BID ADDENDUM NO. 5

October 08, 2018

Johnson Student Center Building Demolition, Increment 1 (Demolition) and Increment 2

RANCHO SANTIAGO COMMUNITY COLLEGE DISTRICT
SANTA ANA, CA

SHEET TITLE
SCHEDULES

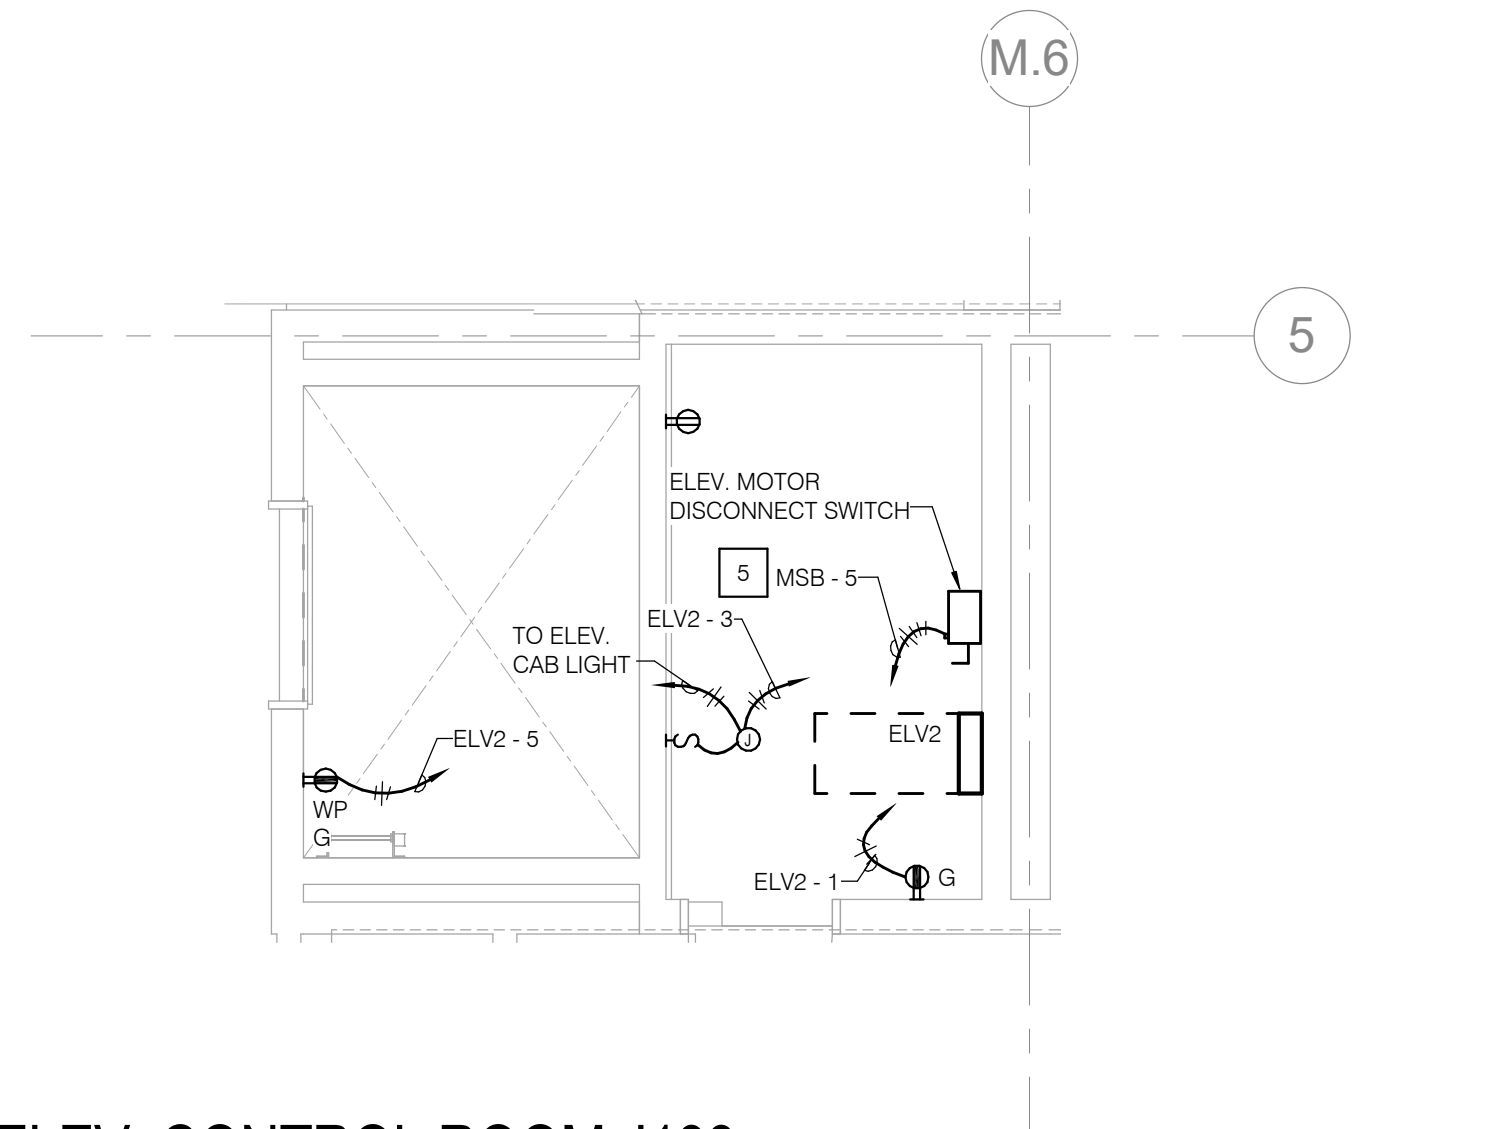
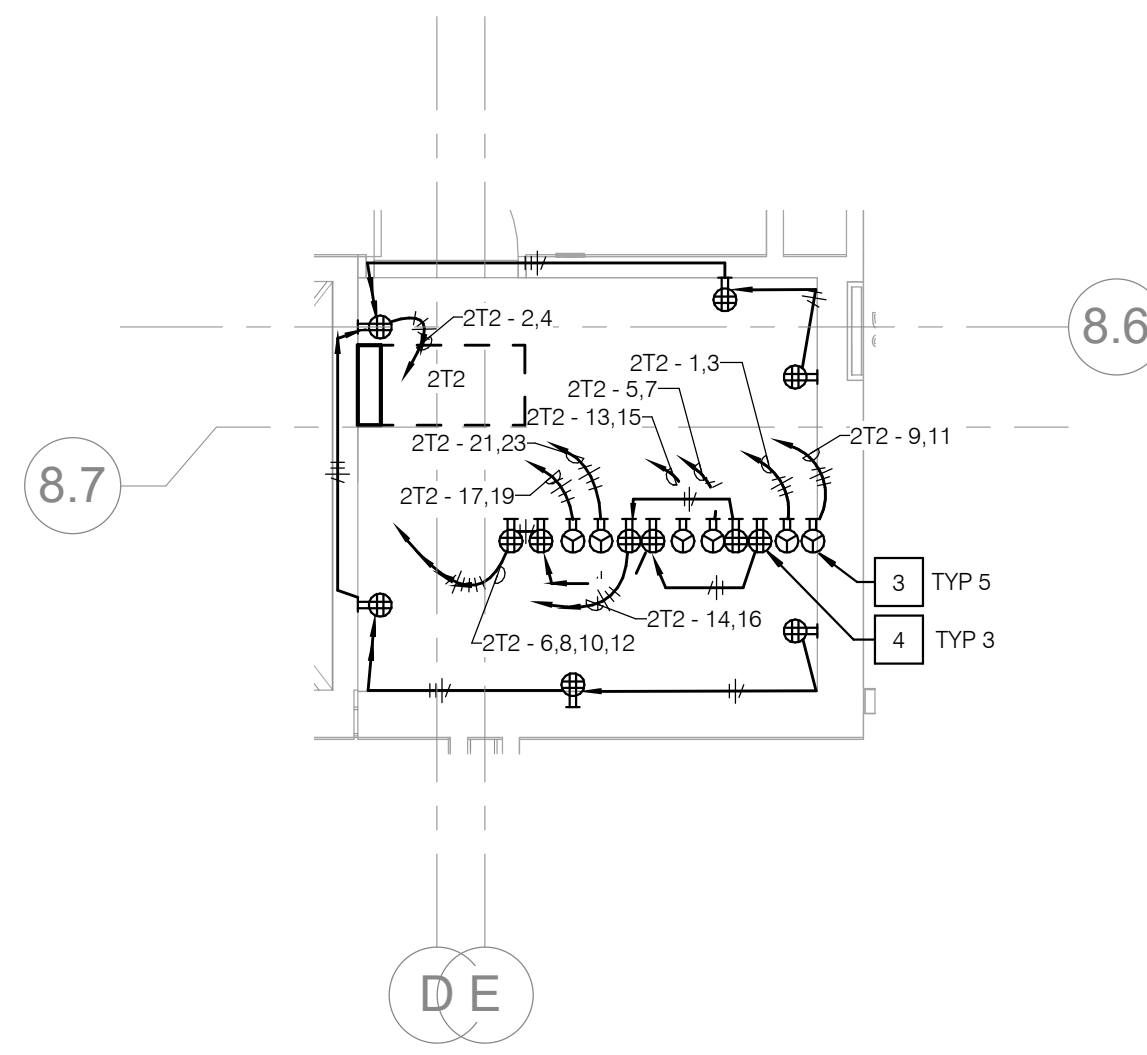
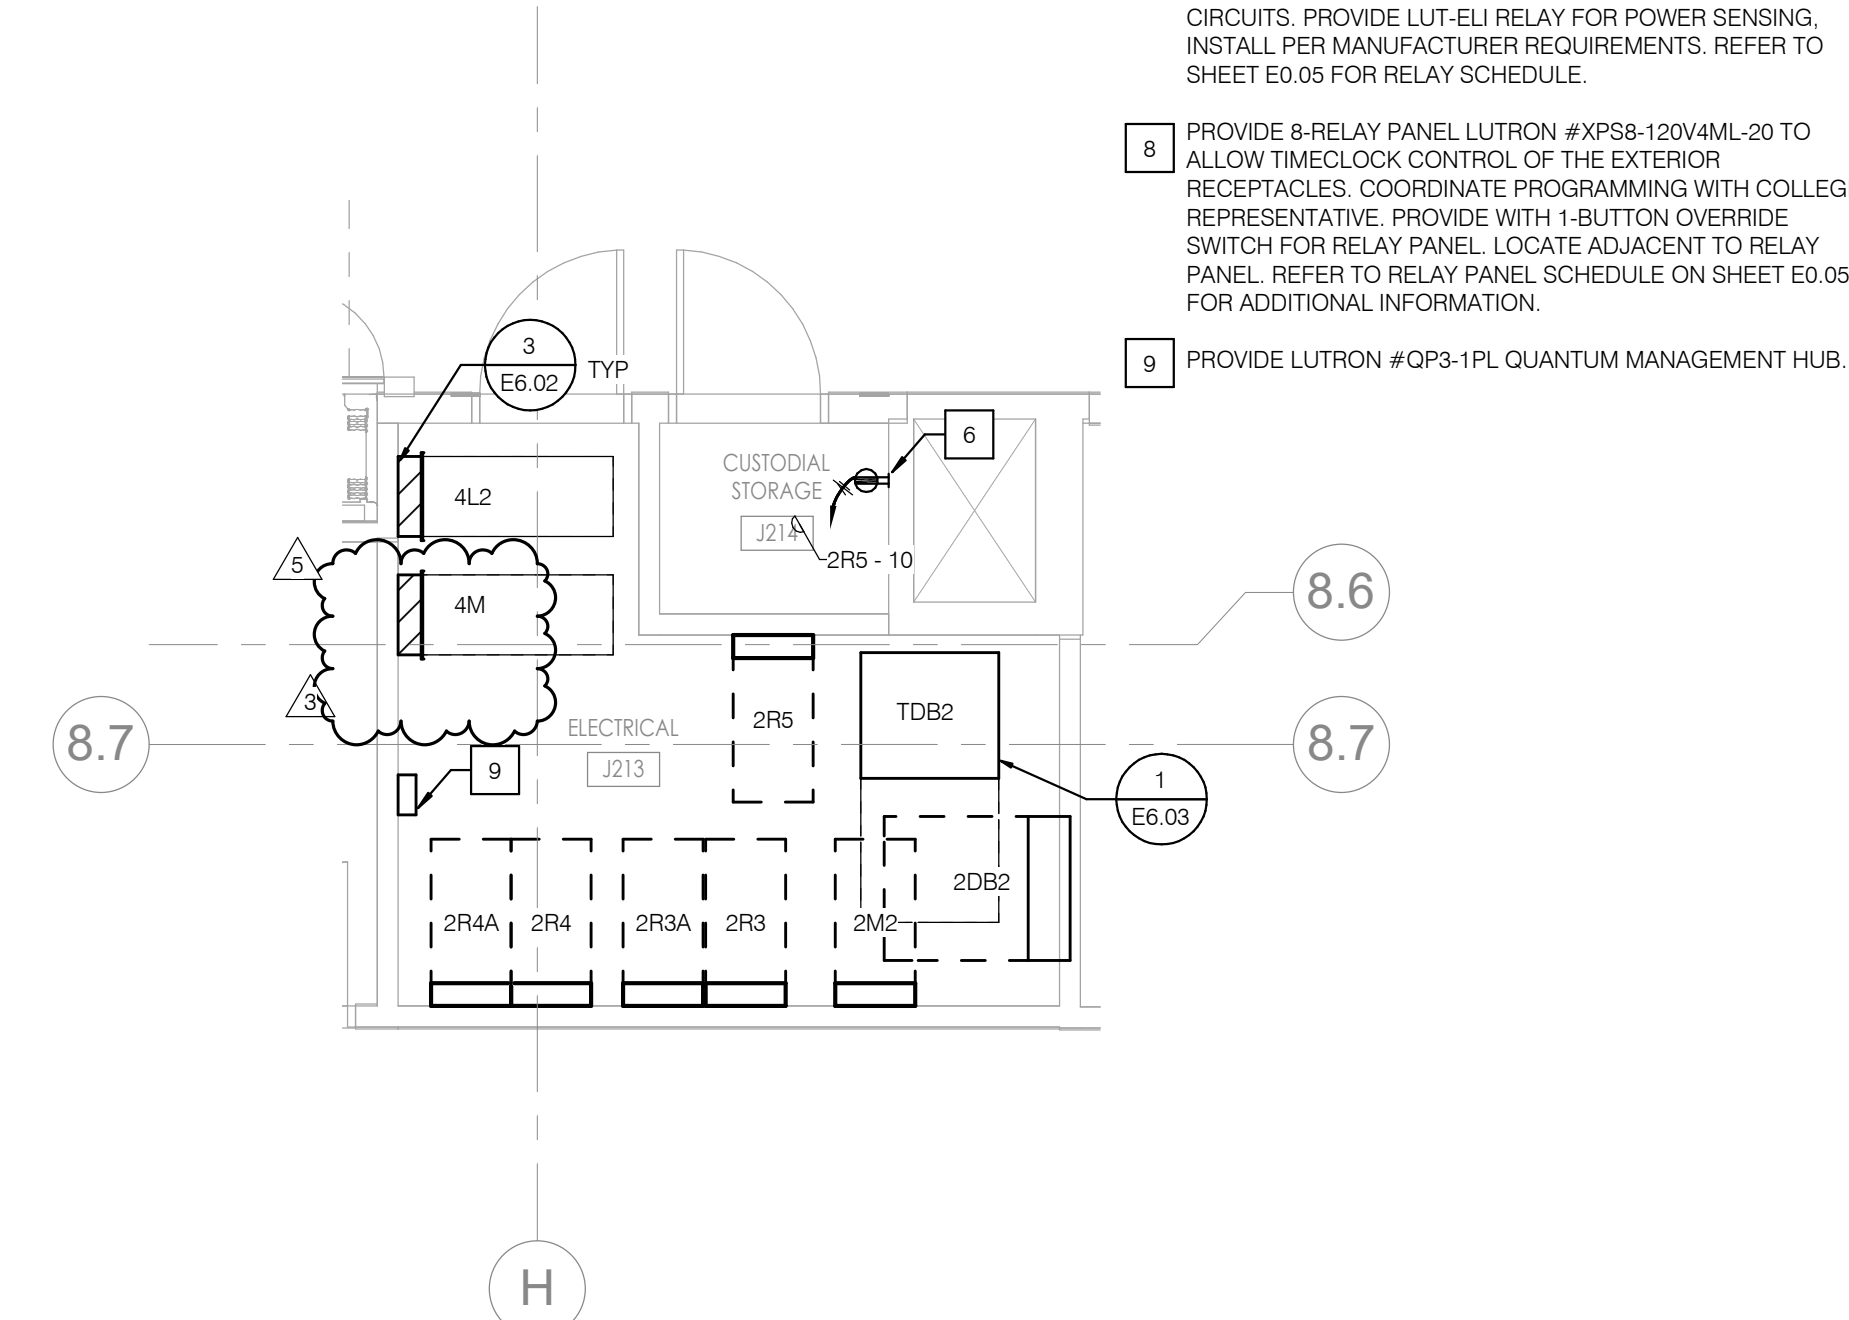
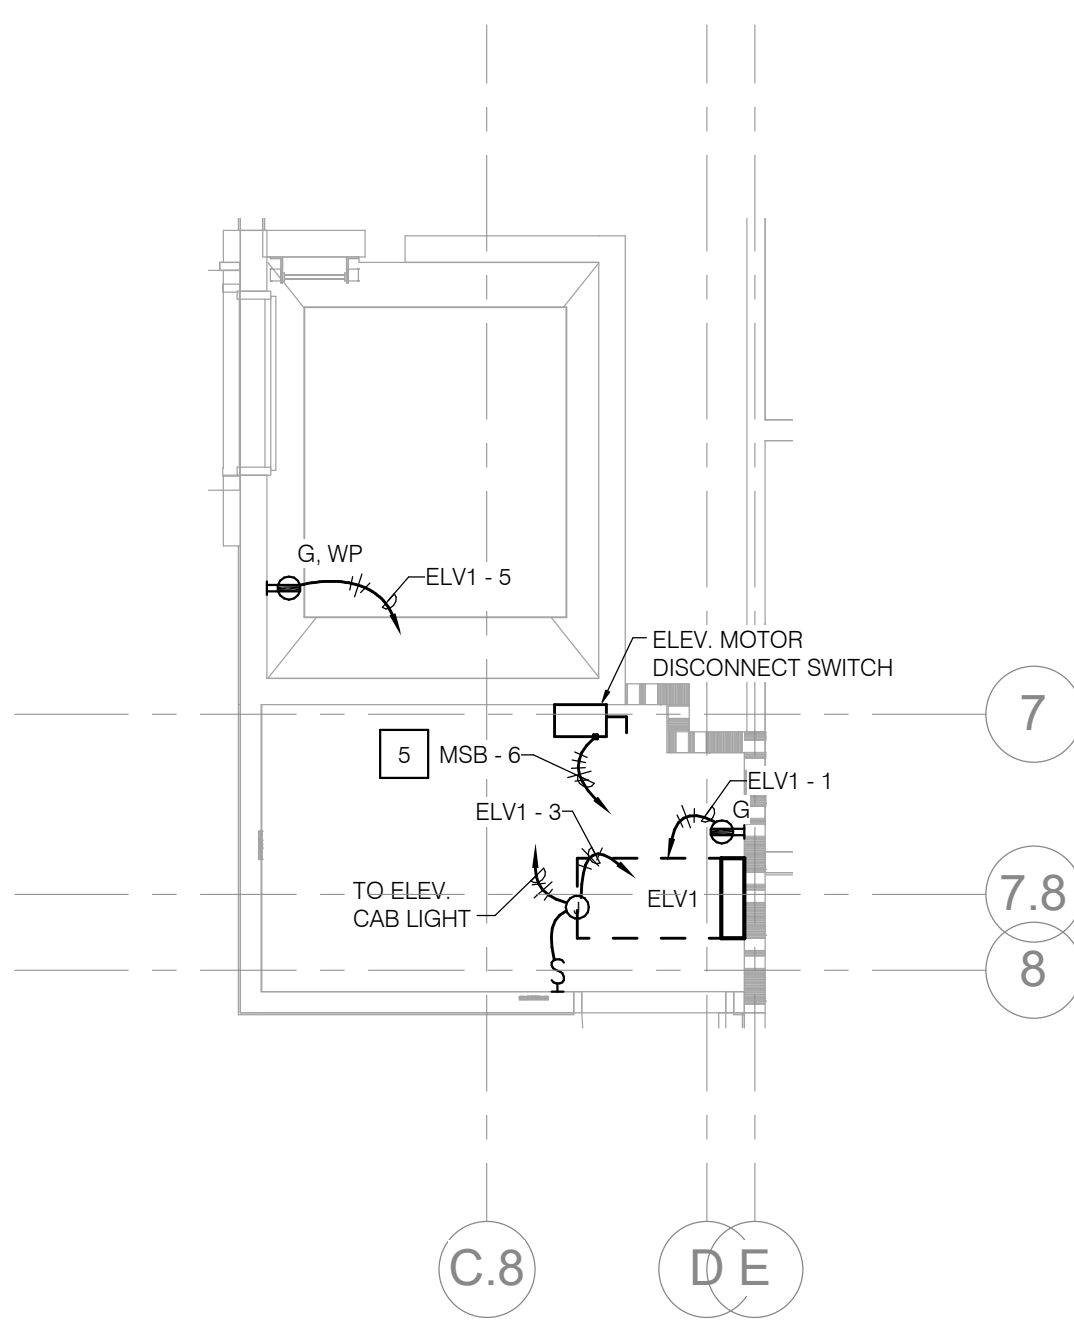
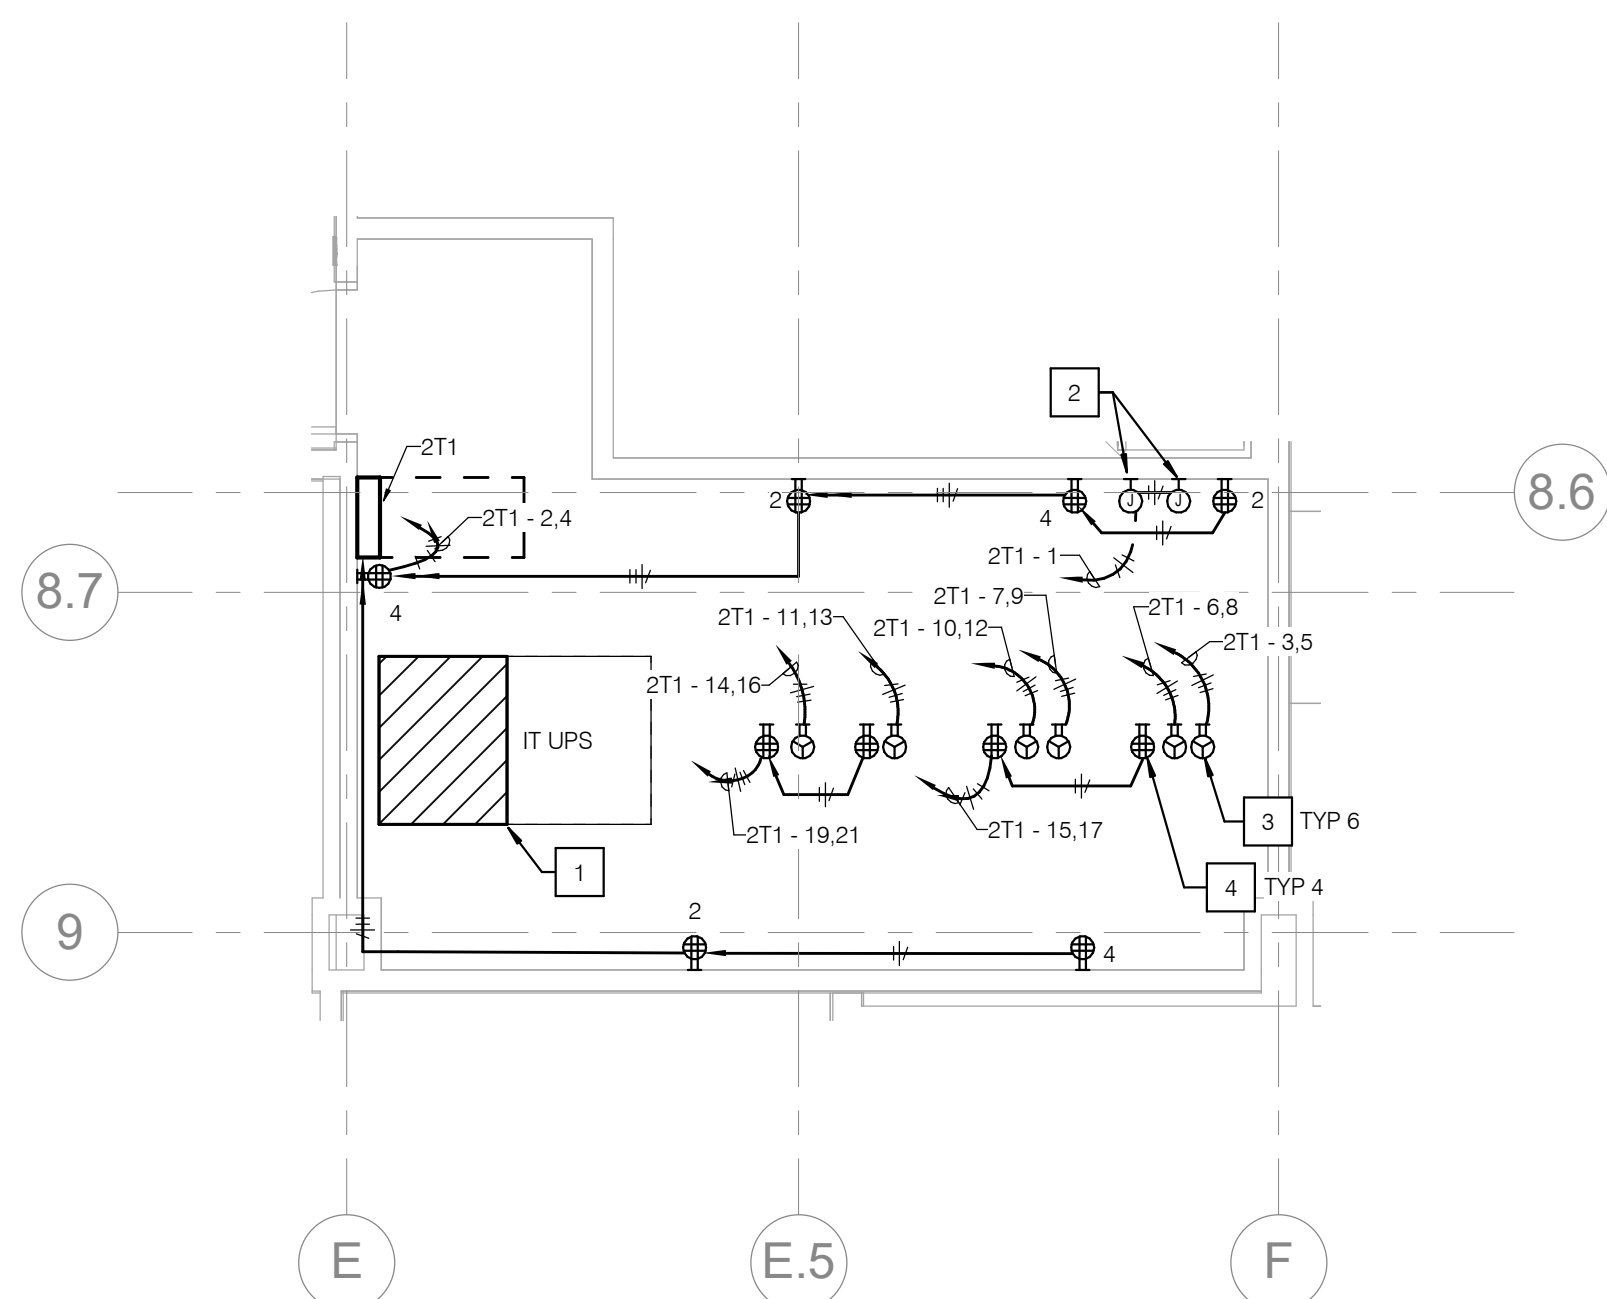
DATE:	09/27/2018		
FROM:	S.Monsen - McCarthy	EMAIL:	SMonsen@McCarthy.com
SPECIFICATION NUMBER:	E0.10	DRAWING NUMBER:	
REQUESTED CLARIFICATION:			
Increment #2 - Panelboard "4M" on drawing E0.10 is missing required amperage, main breaker or main lug size and missing required quantity and sizes of branch circuit breakers. Please advise what will be required.			
RESPONSE TO CLARIFICATION, SUBMITTED AS PART OF AN ADDENDUM:			
Panelboard 4M was shown with a distribution board schedule. Refer to Addendum #5 for revised schedule including all information.			
Melissa Klug, P2S 10/1/18			
RESPONSE PROVIDED BY:	Melissa Klug / P2s	DATE:	10/08/18
